SUBJECT: BYRON STATION, UNITS 1 AND 2 – STAFF ASSESSMENT OF RESPONSE
TO 10 CFR 50.54(f) INFORMATION REQUEST – FLOOD-CAUSING
MECHANISM REEVALUATION (CAC NOS. MF3893 AND MF3894)

STAFF ASSESSMENT BY THE OFFICE OF NUCLEAR REACTOR REGULATION
RELATED TO FLOODING HAZARD REEVALUATION REPORT
NEAR-TERM TASK FORCE RECOMMENDATION 2.1
BYRON STATION, UNITS 1 AND 2
DOCKET NOS. 50-454 AND 50-455

Figure 3.1-3: Byron Nuclear Generating Station Topography derived from Kaegi (2014).

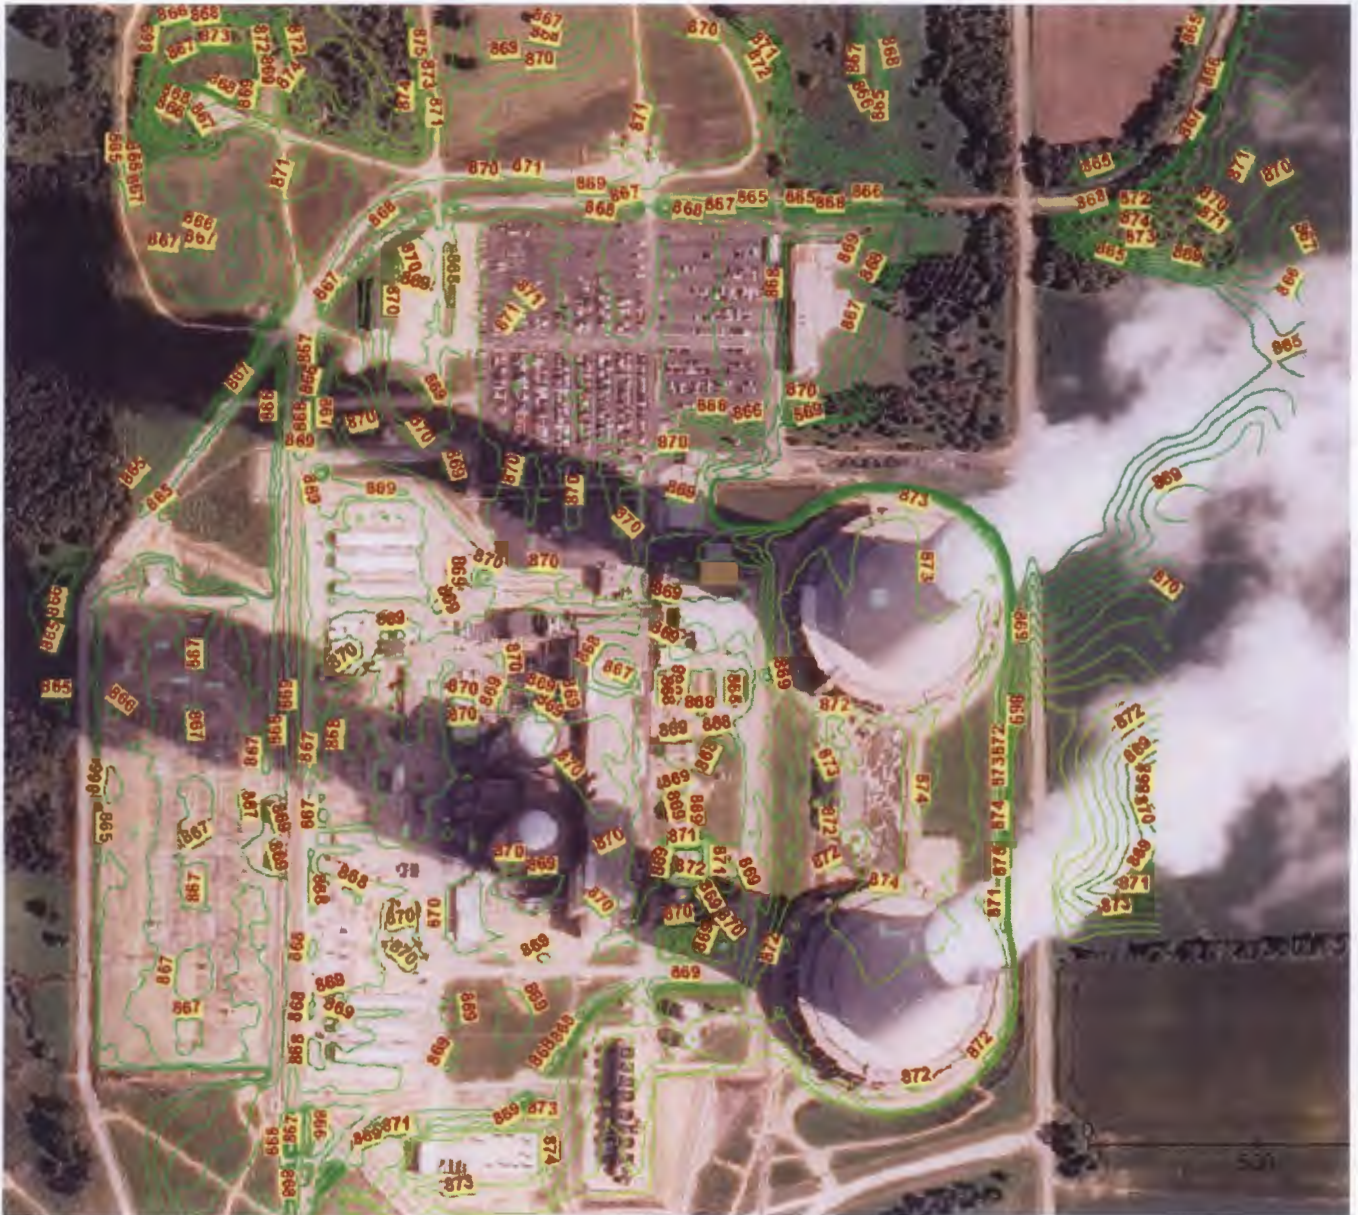
According to the Byron FHRR (Exelon, 2014a), the plant elevation grade is at an elevation of 869.0 ft (264.87 m) NGVD29 and the floor elevation of safety-related buildings is 870.0 ft (265.18 m) NGVD29. The topography, as seen in Figure 3.1-3, shows that the site is relatively flat and is generally lower than 870 ft (265.18 m) NGVD29. The safety-related elevation of equipment at the river screen house is 702.0 ft (213.97 m) NGVD29 (Exelon 2014).

Figure 3.3-1. Locations of upstream and downstream boundaries and cross sections in the HEC-RAS model, the river Screen House, and USGS gage 05440700 (Kaegi, 2015).

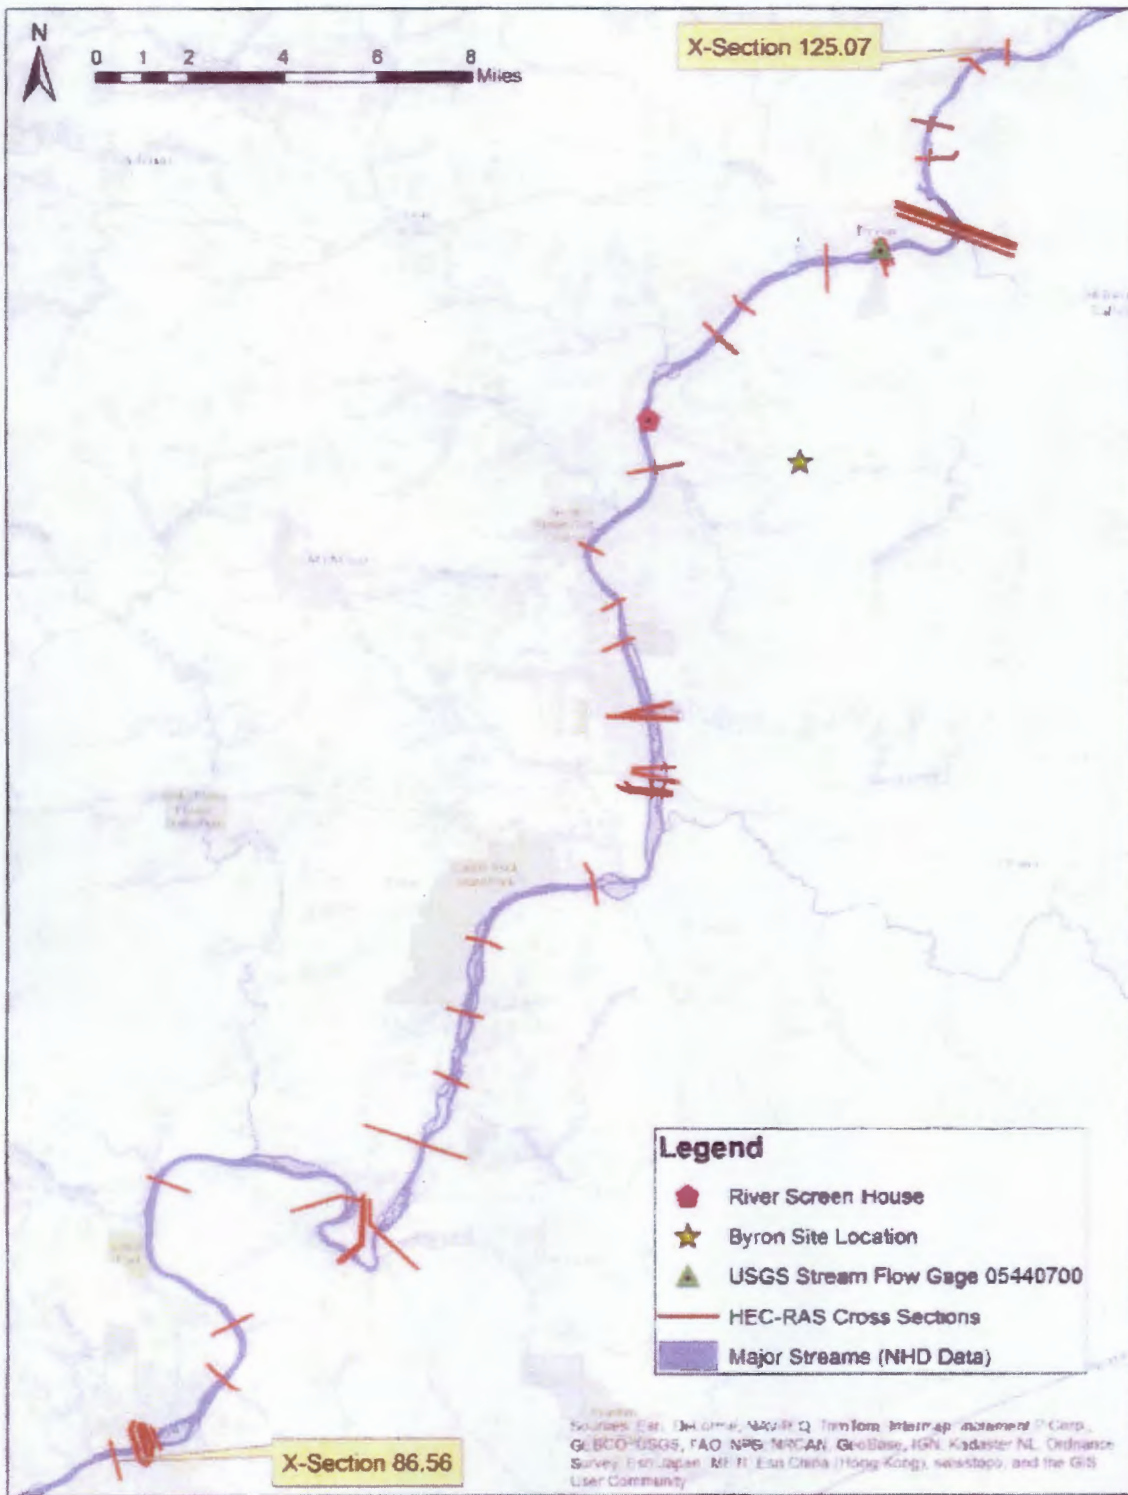
and Dixon Dams were also included in the HEC-RAS model (Kaegi, 2014). Locations of upstream and downstream boundaries and cross sections in the HEC-RAS model, the river screen house, and USGS gage 05440700 are shown in Figure 3.3-1 (and in Figure 3.1-1). The downstream boundary was set as a normal depth condition in the HEC-RAS model, while the upstream boundary was an inflow hydrograph estimated from HEC-HMS analysis of the watershed (see Section 3.3.2 of this staff assessment) (Kaegi, 2014). The NRC staff reviewed the model components, geometry and spacing of cross sections, and structures and concluded that the HEC-RAS model construction is reasonable and the data sources used for developing the model are acceptable. The NRC staff also verified that the WSE at the river screen house was not sensitive to the normal depth condition at the downstream boundary or to dam operation at two downstream dam structures (Oregon and Dixon Dams).

The licensee calibrated the HEC-RAS model to three historical events with high peak water surface elevations by adjusting the Manning's roughness coefficients for the river channel and the overbank until the simulated WSE was the same as or less than 1 ft (0.30 m) above the observed water surface elevation at the Byron USGS gage (RM 120.04; 193.2 km) (Figure 3.3-1) (Kaegi, 2015). The final Manning's roughness coefficients used in the calibrated HEC-RAS model were 0.03 for the river channel and 0.1 for the overbank. However, the staff noted that the historical peak flows used for model calibration were less than 20 percent of the controlling PMF flow rate. The licensee provided the following support information regarding the ability of the model calibration to address the uncertainty of Manning's roughness coefficient over greater flood depths and surface area during the PMF: (1) the Manning's roughness coefficient is conservative for the overbank land use and type along the Rock River reach included in the HEC-RAS model, and (2) greater depths in the river channel tend to reduce the flow resistance of roughness features (Kaegi, 2015). The staff performed an independent sensitivity analysis by increasing Manning's roughness coefficients up to 25 percent and confirmed that the licensee's resultant maximum WSE was reasonable.

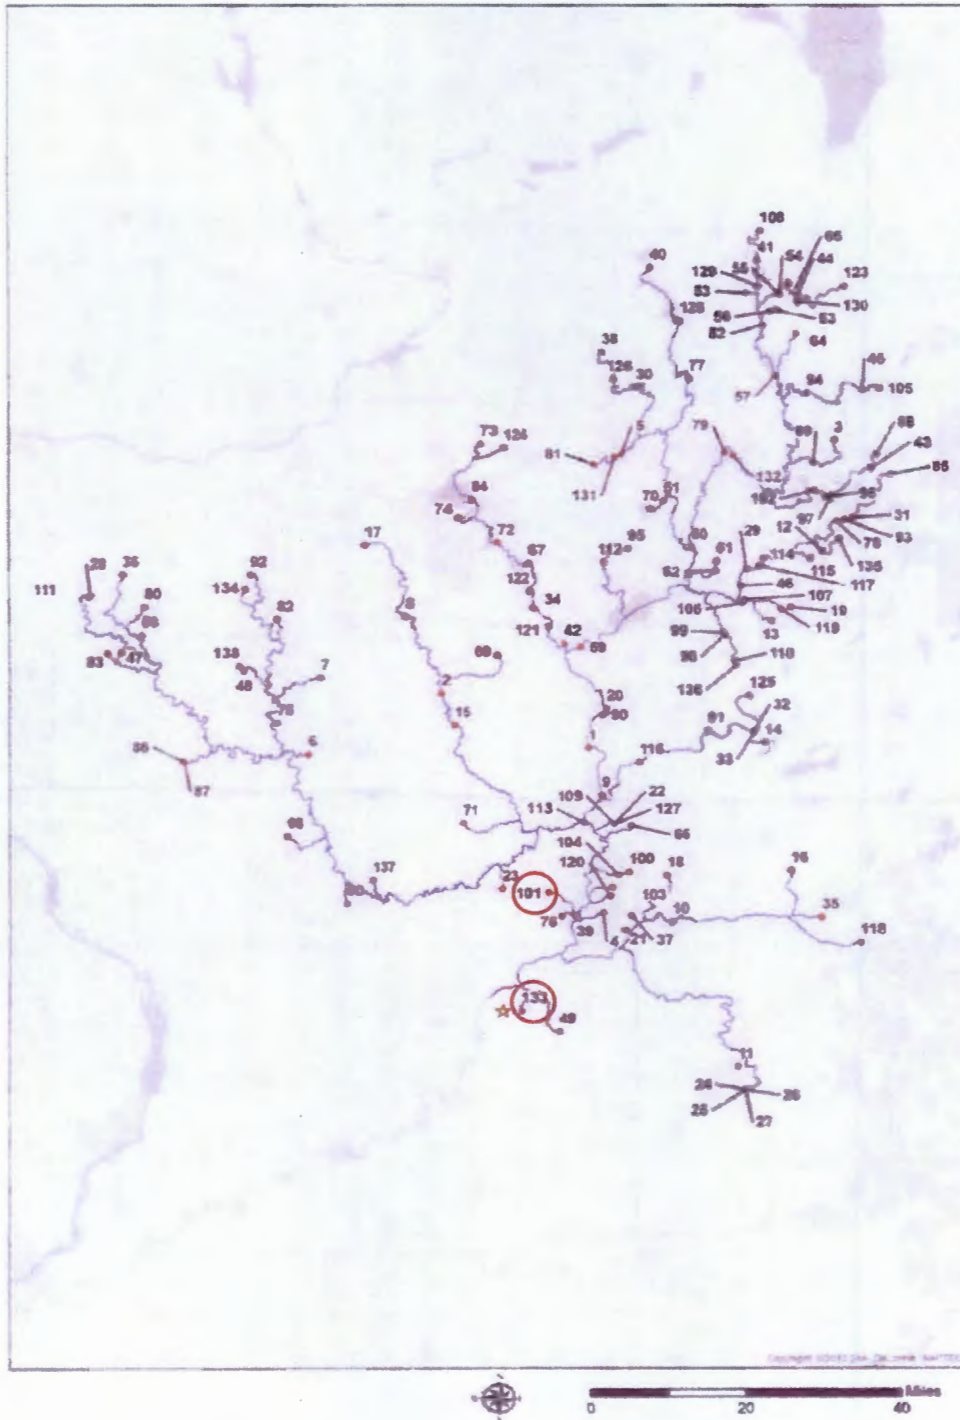
The licensee identified dams upstream from the Byron site within the Rock River watershed by using the USACE National Inventory of Dams (NID) database (Exelon, 2014a) (Figure 3.4-1). The licensee evaluated the effects of hydrologic dam failures with a simplified approach that used one hypothetical dam representing the total storage of the identified dams (Exelon, 2014a). The hypothetical dam was placed at the nearest NID dam location (dam no. 133 in Figure 3.4-1), approximately 12 mi (19 km) upstream from the Byron's River Screen House. The licensee stated that most of the dams in the Rock River watershed are low-head dams because of the relatively low topographic relief of the area (Kaegi, 2015). The storage volume of a single hypothetical dam was estimated as the sum of maximum storage volumes for the 138 individual dams identified in the NID database (Kaegi, 2015). The height of the hypothetical dam was assumed as an average storage-weighted height for all the dams identified from the NID database (Kaegi, 2015). Figure 3.4-1 shows the locations of the dams from the NID database. The licensee evaluated the following methods to compute the peak flows from the hypothetical dam breach (Kaegi, 2015): the US Bureau of Reclamation method (USBR, 1982), the Natural Resources Conservation Service method (NRCS, 1985), and the method of Froehlich (1995). The licensee calculated the largest peak breach outflow from hydrologic dam failure using Froehlich's (1995) equation (Kaegi, 2015).

The licensee completed a sensitivity analysis of the hydraulic dam failure using a HEC-HMS model with a reach routing network (Kaegi, 2015) for comparison with the simplified approach reported in the FHRR. The sensitivity analysis included all 138 dams (Figure 3.4-1) and simulated the accumulated flow from the progressive dam failures routed through the reach network by the HEC-HMS model (Kaegi, 2015). The dam characteristics for each dam were estimated from those identified in the NID database (Kaegi, 2015). The estimated dam failure flow hydrograph from the HEC-HMS model was added on to the PMF hydrograph in the HEC-RAS model (Kaegi, 2015). The licensee found that this approach produced a lower WSE at Byron's river screen house than the simplified dam failure analysis using one hypothetical dam with a storage-weighted height and total storage based on all 138 reservoirs (Kaegi, 2015). The staff reviewed the sensitivity analysis and found that although it provided an accurate simulation of the accumulated effect of failures of all dams in series along Rock River within the watershed, it was less conservative than the simplified hypothetical dam failure analysis. The staff concluded that the results from the simplified hypothetical dam failure analysis were reasonable.
